**NC Department of Insurance  
Office of the State Fire Marshal - Engineering Division  
1202 Mail Service Center, Raleigh, NC 27699-1202  
919-661-5880**

**Dryer Duct Rated Assembly Membrane Penetrations**

**Code:** 2012 NC Building Code  
**Section:** 716.6.2

**Code:** 2012 NC Mechanical Code  
**Section:** 504.2 & 607.6.2

**DRYER DUCT DETAIL  
SECTION A**

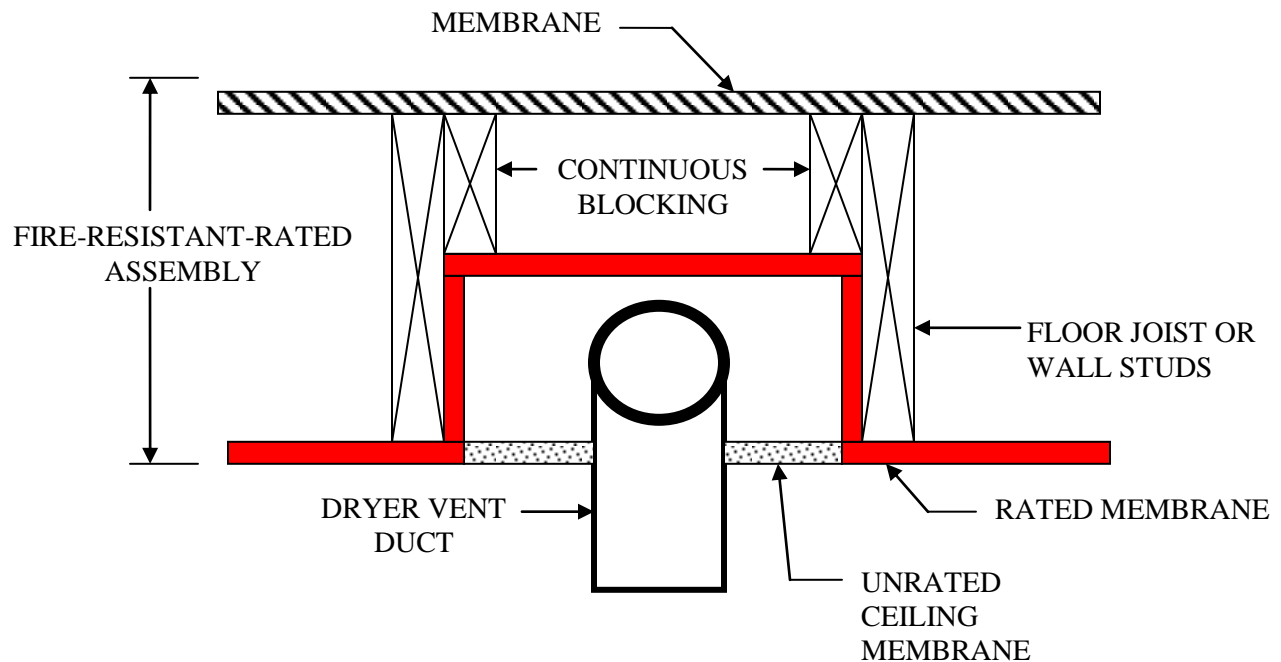
Since Section 504.2 of the NC Mechanical Code prohibits the placement of fire dampers and smoke dampers in dryer ducts, can a dryer duct penetrate the membrane of a rated floor/ceiling, roof/ceiling, or wall assembly?

- 1) The duct can be wrapped with rated duct wrap from the point that the duct enters the rated assembly to the point where it leaves the rated assembly (see Section A). The duct wrap must be listed and labeled for the specific intended use. The duct wrap must be rated the same as the floor/ceiling assembly, roof/ceiling, or wall assembly. The penetration must be sealed to prevent the passage of smoke or flame.
